# UNITED STATES PATENT AND TRADEMARK OFFICE

APPLICATION NO.	FILING DATE	FIRST NAMED INVENTOR	ATTORNEY DOCKET NO.	CONFIRMATION NO.
10/500,583	06/29/2004	Jan Webjorn	P/4447-3 PCT	5248
2352	7590	02/25/2008	EXAMINER	
OSTROLENK FABER GERB & SOFFEN 1180 AVENUE OF THE AMERICAS NEW YORK, NY 100368403			AMIRI, NAHID	
ART UNIT		PAPER NUMBER		
3679				
MAIL DATE		DELIVERY MODE		
02/25/2008		PAPER

<b>Office Action Summary</b>	<b>Application No.</b>	<b>Applicant(s)</b>	
	10/500,583	WEBJORN, JAN	
	<b>Examiner</b>	<b>Art Unit</b>	
	Nahid Amiri	3679

## **DETAILED ACTION**

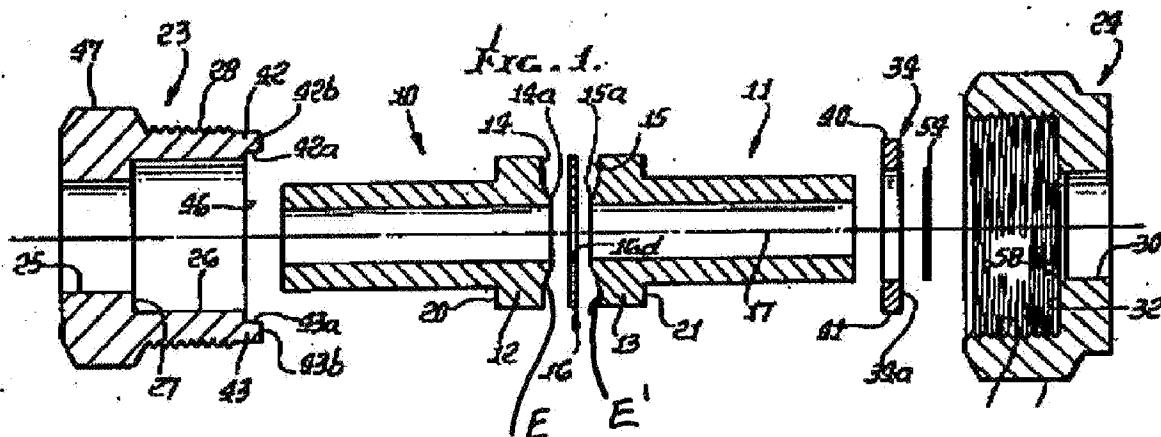
**Claims 1-5 and 10-14 are rejected under 35 U.S.C. 103(a) as being unpatentable over US Patent No. 5,040,714 McManigal.**

With respect to claim 1, McManigal discloses a flanged member (Fig. 1) to be included as a first flanged member (12) in a flanged joint; wherein the flanged member (12) comprising a first flanged end with a first end surface (E) inherently forming a load transferring surface through which forces are transferred when assembled together with a corresponding end surface of a flanged end (E') of a second flanged member (13) in the flanged joint, at least a portion of the first end surface (E) in unstressed condition being concave in a radial direction such that the at least a portion of the first end surface (E) is curved and defined by a concave curve function; and in an unstressed condition a proximal point on the at least the portion of the first end surface and a distal point of the at least the portion of the first end surface meet a plane inclined in the radial direction of the flanged member (12). McManigal does not disclose that the first end surface is concave in the radial direction over at least an area that is subjected to deformation when the flanged member is assembled together with the second flanged member. It is notoriously old, well-known and conventional that all materials deform when undergo some external force. Therefore, it would have been obvious to one of ordinary skill in the art at the time of invention was made to provide the flange member of McManigal with some deformation when the flange member undergo some external force in order to close the gap between the flange member and other member.

With respect to claim 2, McManigal discloses (Fig. 1) that the first end surface is concave over the entire extension thereof in the radial direction.

With respect to claim 3, McManigal discloses (Fig. 1) that the first end surface (E) is concave in the radial direction over at least an area that will be subjected to deforming forces during use.

With respect to claim 4, McManigal discloses (Fig. 1) that the first end surface (E) is concave over essentially a contact surface against the corresponding end surface (E') of the second flanged member (13).

With respect to claims 5 and 14, McManigal discloses (Fig. 1) that the first end surface (E) comprises varyingly concave surface in the radial direction; and wherein the concave surface (E) has more than one radii of curvature.

With respect to claim 10, McManigal discloses (Fig. 1) that at least a part of a transition area, between the surface of the flange directed away from the end surface and a part of the flanged member that is substantially parallel to a longitudinal axis of the member, is shaped as a substantially elliptical area.

With respect to claim 11, McManigal discloses a Joint (Fig. 1) comprising two flanged members (12, 13); the two flanged members (12, 13) each comprising at least one flanged end having an end surface (E) forming a load transferring surface through which forces are

transferred when connecting together the two flanged members (12, 13) in an assembled state such that the end surfaces face each other, wherein for at least one of the two flanged members (12, 13), at least one portion of the end surface (E) in an unstressed condition is concave in a radial direction such that the at least the portion of the end surface is defined by a concave curve function, and a proximal point on the at least the portion of the first end surface (E) and a distal point of the at least the portion of the first end surface meeting a plane inclined in the radial direction of the flange member (12). McManigal does not disclose that the first end surface is concave in the radial direction over at least an area that is subjected to deformation when the flanged member is assembled together with the second flanged member. It is notoriously old, well-known and conventional that all materials deform when undergo some external force. Therefore, it would have been obvious to one of ordinary skill in the art at the time of invention was made to provide the flange member of McManigal with some deformation when the flange member undergo some external force in order to close the gap between the flange member and other member.

With respect to claim 12, McManigal discloses (Fig. 1) both of the flanged members (12, 13) have a concave end surface.

With respect to claim 13, McManigal discloses (Fig. 1) the end surfaces (30, 16) facing each other before assembly are inclined in the radial direction outwards to form an angle in radial cross-section, the angle being such that a distance between the two end surfaces (E, E') increase in radial direction outwards, and at least one of the inclined end surface being slightly concave; and wherein the concave surface has more than one radii of curvature.

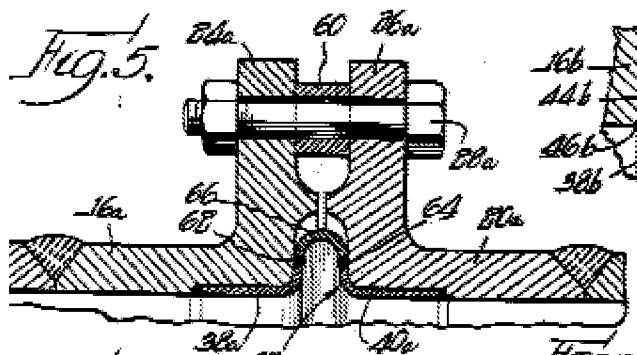
**Claims 1-7 and 11-14 are rejected under 35 U.S.C. 102(b) as being anticipated by US Patent No. 2,739,828 Schindler et al.**

With respect to claim 1, Schindler et al. disclose a flanged member (Fig. 3) to be included as a first flanged member (24a) in a flanged joint; wherein the flanged member (24a) comprising a first flanged end with a first end surface (F) configured to be assembled together with a corresponding end surface of a flanged end (F') of a second flanged member (26a) in the flanged joint, at least a portion of the first end surface (F) in unstressed condition being concave in a

radial direction such that the at least a portion of the first end surface (F) is curved and defined by a concave curve function; and wherein in an unstressed condition a proximal point on the at least the portion of the first end surface and a distal point of the at least the portion of the first end surface meet a plane inclined in the radial direction of the flanged member (24a).

With respect to claim 2, Schindler et al. disclose (Fig. 5) that the first end surface (F) is concave over the entire extension thereof in the radial direction.

With respect to claim 3, Schindler et al. disclose (Fig. 5) that the first end surface (F) is concave in the radial direction over at least an area that will be subjected to deforming forces when the flanged member (24a) is assembled together with another flanged member (26a).

With respect to claim 6, Schindler et al. disclose (Fig. 5) that the flange member further comprising an internal through axial opening (A), the first end surfaces (F) having an innermost abutment point against the corresponding end surface (F') of the second flanged member (26a),

which abutment point is situated farthest in the radial direction at the opening (A), the concavity of the first end surface (F) extending all the way in to the abutment point.

With respect to claim 7, Schindler et al. disclose (Fig. 5) that the first end surface (F) has an innermost abutment point against the corresponding end surface (F') of the second flanged member (24a), an internal through axial opening (A') of the second flanged member (26a), the innermost abutment point being situated nearest in the radial direction to the opening (A), and the concavity of the first end surface (F) extending all the way in to the abutment point.

With respect to claim 11, Schindler et al. disclose (Fig. 5) comprising two flanged members (24a, 26a); the two flanged members (24a, 26a) each comprising at least one flanged end having an end surface (F) connecting together the two flanged members (24a, 26a) in an assembled state such that the end surfaces face each other, wherein at least one portion of the end surface in an unstressed condition is concave in a radial direction such that the at least the portion of the end surface is defined by a concave curve function, one of the end surfaces (F) is concave in the radial direction over at least an area that is subjected to deformation when one of the flanged members (12) is assembled together with said second flanged member (13), a proximal point on the at least the portion of the first end surface (F) and a distal point of the at least the portion of the first end surface (F) meeting a plane inclined in the radial direction of the flange member (24a).

With respect to claim 12, Schindler et al. disclose (Fig. 5) both of the flanged members (24a, 26a) have a concave end surface.

With respect to claim 13, Schindler et al. disclose (Fig. 5) the end surfaces (F, F') facing each other before assembly are inclined in the radial direction outwards to form an angle in radial cross-section, the angle being such that a distance between the two end surfaces (F, F') increase in radial direction outwards, and at least one of the inclined end surface being slightly concave; and wherein the concave surface has more than one radii of curvature.
